**PCO #038**

**Project:** 21-501 - Collin County Adult Detention Facility, Phase 1 Addition  
 4300 Community Avenue  
 McKinney, Texas 75071

**Prime Contract Potential Change Order #038: PR #9R Future Ductwork and Raceways at Female Shell Out Space**

**PROJECT:** Collin County Adult Detention Facility **PROPOSAL REQUEST 09R**  
4300 Community Avenue  
McKinney, TX 75071

**LEVEL 1 WEST -  
FLOOR PLAN**

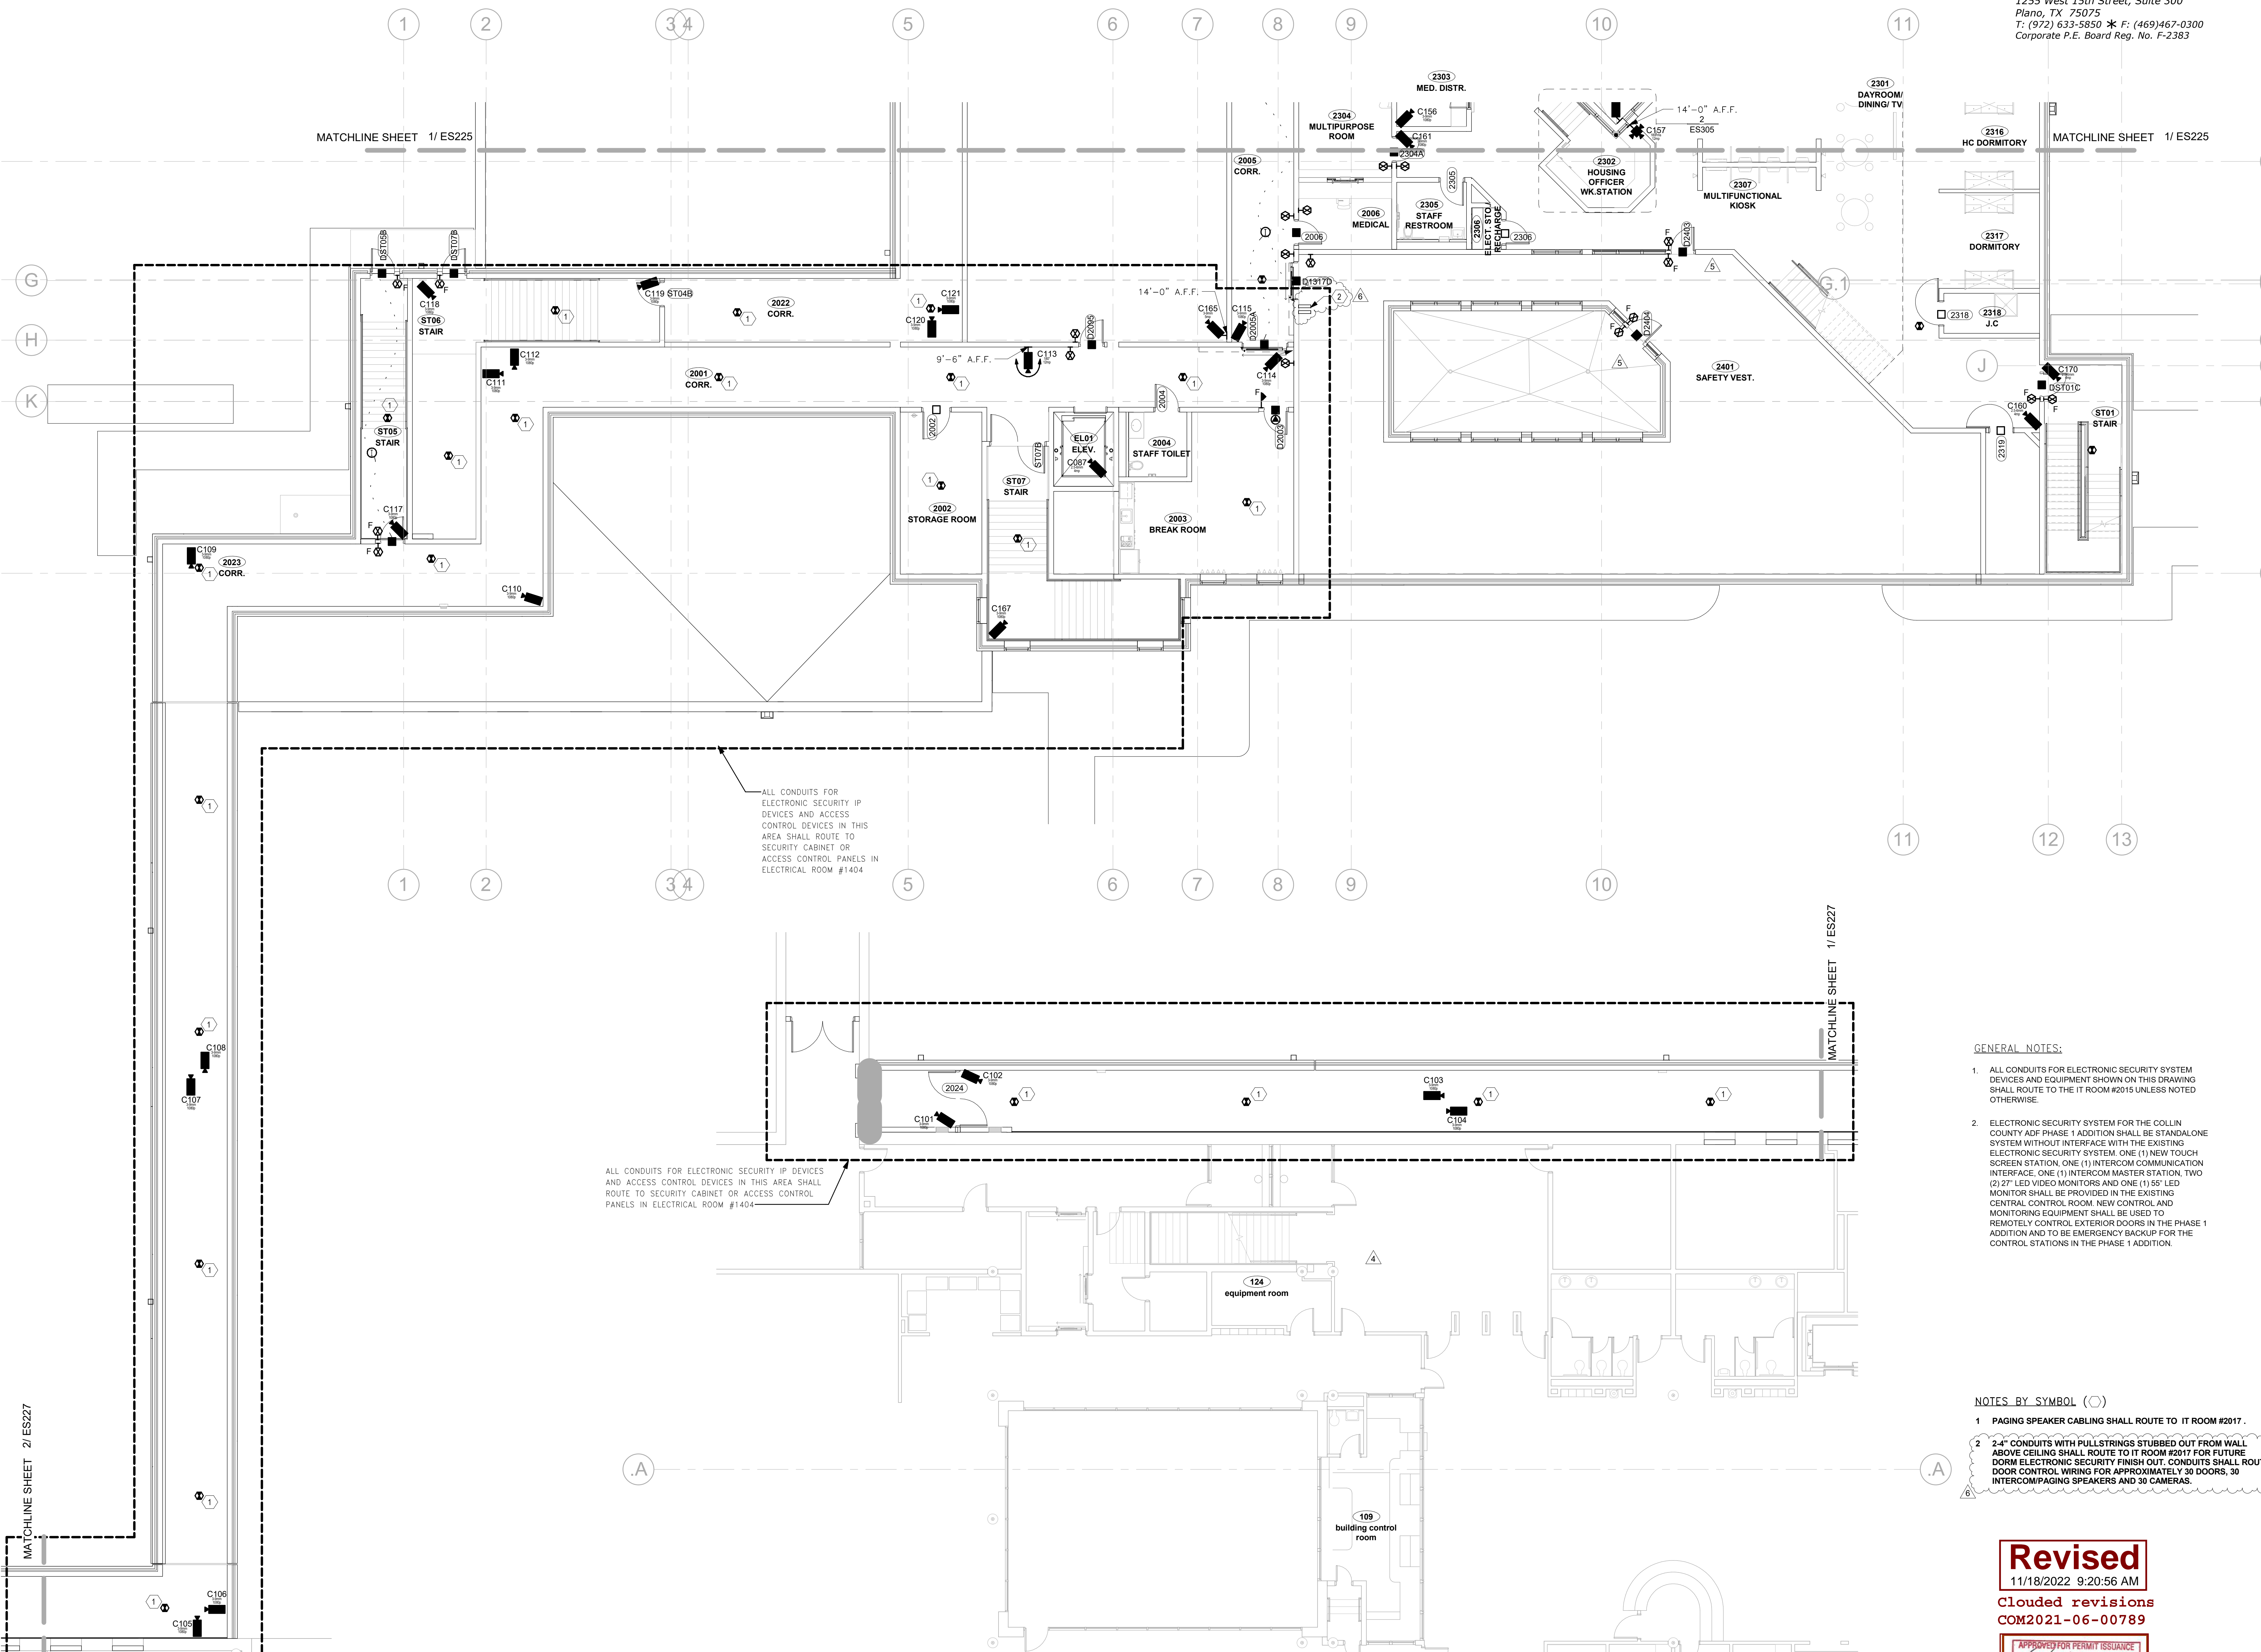
- PAGING SPEAKER CABLING SHALL ROUTE TO IT ROOM #2017.
- 2-4" CONDUITS WITH PULLSTRINGS STUBBED OUT FROM WALL ABOVE CEILING SHALL ROUTE TO IT ROOM #2017 FOR FUTURE DORM ELECTRONIC SECURITY FINISH OUT. CONDUITS SHALL ROUTE DOOR CONTROL WIRING FOR APPROXIMATELY 30 DOORS, 30 INTERCOM/PAGING SPEAKERS AND 30 CAMERAS.
